# UNITED STATES PATENT AND TRADEMARK OFFICE

10/759,527

J. Michael Lee

## **DETAILED ACTION**

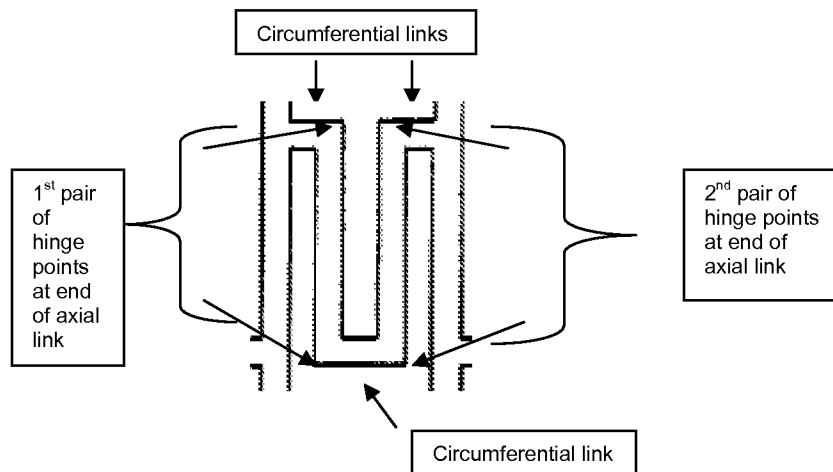
Claims 1-17 are rejected under 35 U.S.C. 112, second paragraph, as being indefinite for failing to particularly point out and distinctly claim the subject matter which applicant regards as the invention. In claims 1 and 3, it is not understood how the new limitation in claims 1 and 3 that the hinge points “define an axis of rotation between adjacent links”.... facilitate relative rotation of said links. Since it is not understood how the links are considered to rotate, this is indefinite. Rotate is defined to permit a complete turn about a center point. The links of the claimed invention are not attached by any type of ball joint which is structure that permits rotation, and thus to define the invention such that it permits rotation is indefinite. The Examiner understands there is pivoting or bending of links, just like the prior art, but the structure is clearly not designed to permit complete rotation.
